# **APPLICANT'S RESPONSES TO ISSUES RAISED AT DEADLINE 2**

## **Drax Bioenergy with Carbon Capture and Storage**

Document Reference Number: 8.10.2

Applicant: Drax Power Limited

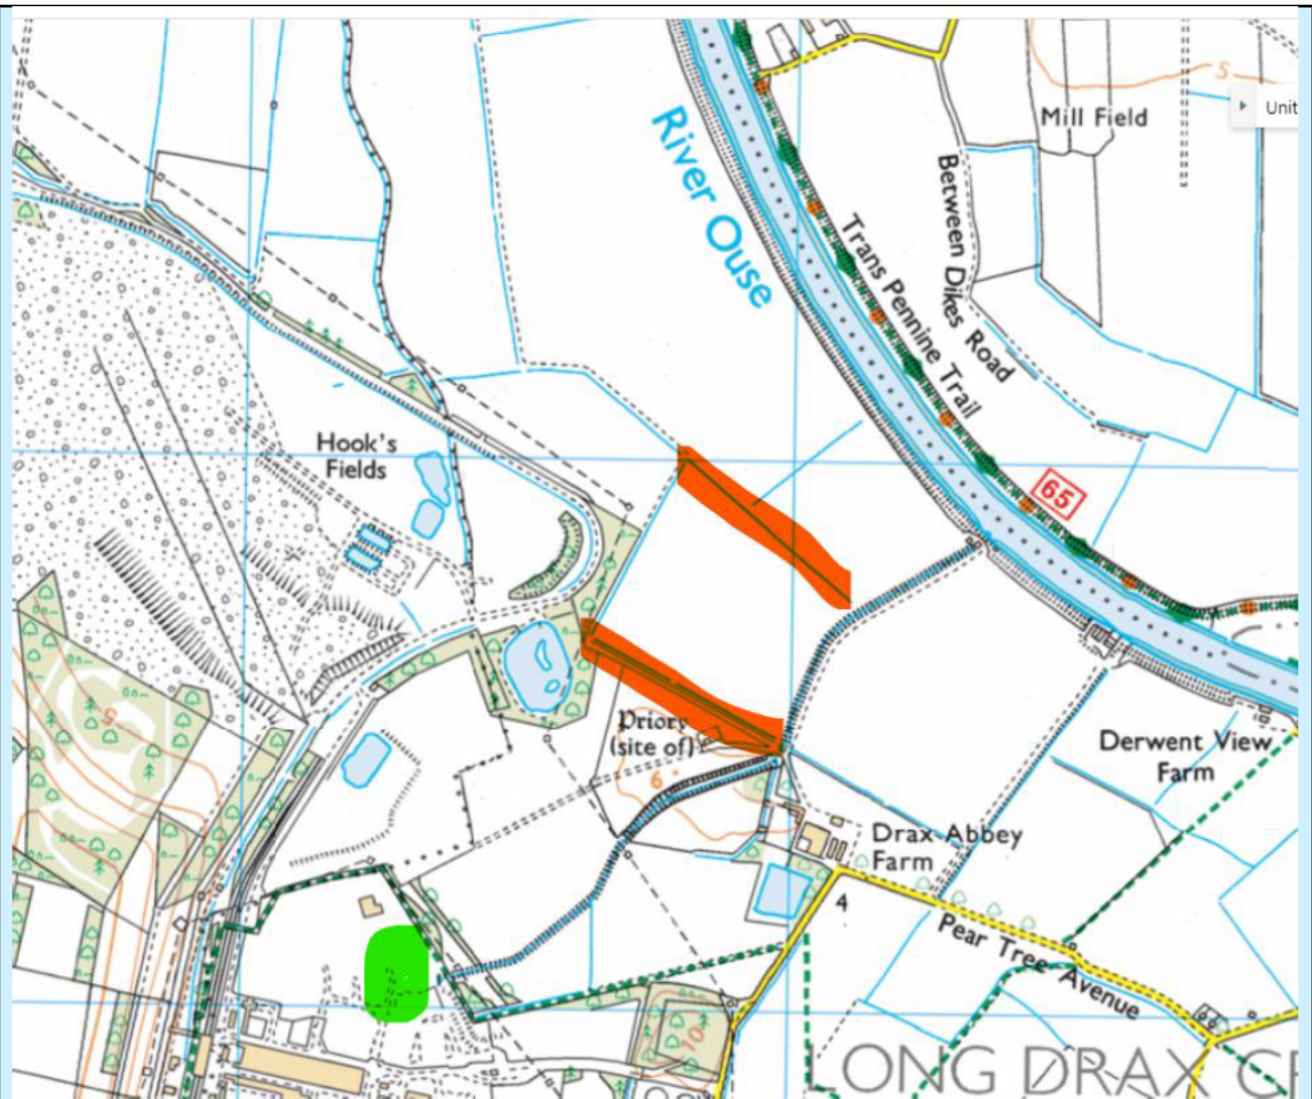
to include in the list of details 'A contingency plan in case of an accident/pollution incident'.	
<b>Draft Development Consent Order</b>		
<b>6.4 (para 7)</b>	<p>Appendix A – CEMP Watercourse Pollution Prevention Plan</p> <p>We welcome the plan in Appendix A which shows the CEMP Watercourse Pollution Prevention Plan boundary. Whilst this is in line with previous discussions, we have had with the Applicant we wish to reiterate that included in the CEMP should be justification for any water features within the 500m buffer that are not within this boundary.</p>	<p>The Applicant remains in discussions with the Environment Agency to agree the water features which are excluded from the Watercourse Pollution Plan Boundary.</p> <p>The Environment Agency require justification for the exclusion of the areas marked in yellow in the plan below:</p>

In the yellow area the OS mapping shows that there are only two minor watercourses of significance, they are highlighted in red in the plan below:

The Applicant considers that these watercourses do not need to be included in the watercourse prevention plan as the Carr Dyke provides a cut off from the works and will

<p>therefore prevent pollution reaching much of the yellow area and the only works proposed north of the Carr Dyke are as follows:</p> <ul style="list-style-type: none"> <li>A) The AGI terminal in the main site boundary (green mark in the above plan), any surface water runoff / accidental spills would preferentially flow into the Carr Dyke (assuming drainage / mitigation systems are bypassed – i.e. full at the time of the spill).</li> <li>B) BNG planting, which is envisaged to be tree whips planted by hand which are not anticipated to result in environmental impacts.</li> </ul> <p>Furthermore, the IDB pumping station on the Carr Dyke / River Ouse confluence will pump waters into the River Ouse preventing back flow (i.e. any waters containing contaminants) up the small channels (highlighted in red in the above plan) apart from times of extreme flood. During times of extreme flood there would be significant dilution of pollutants by flood water, and measures in the CEMP (as secured in the draft DCO Requirement 14) would be implemented as detailed in the REAC (REP02-053 to be submitted at Deadline 3), in particular WE10 and WE14, which would prevent works taking place that are most likely to generate pollution and would manage and mitigate a pollution event should one occur. These measures together would result in minimising the risk of pollution occurring overall.</p> <p>The Environment Agency have agreed with this on the basis that the Carr Dyke does provide a cut-off and that the measures set out in the REAC (particularly WE14 which requires a Watercourse Pollution Prevention Plan to be prepared and agreed with) ensure that no runoff that may enter Carr Dyke in case of an accident, may escape and enter the nearby drains. Further evidence will be provided to the Environment Agency as part of the submission of the Watercourse Pollution Prevention Plan, which is to show the outline flow of these watercourses and demonstrate there is no connectivity. Should conditions change, for example excessive wet weather, the Watercourse Pollution Prevention Plan will be reviewed and revised as necessary. This has been captured in the REAC (REP02-053 to be submitted at Deadline 3).</p>
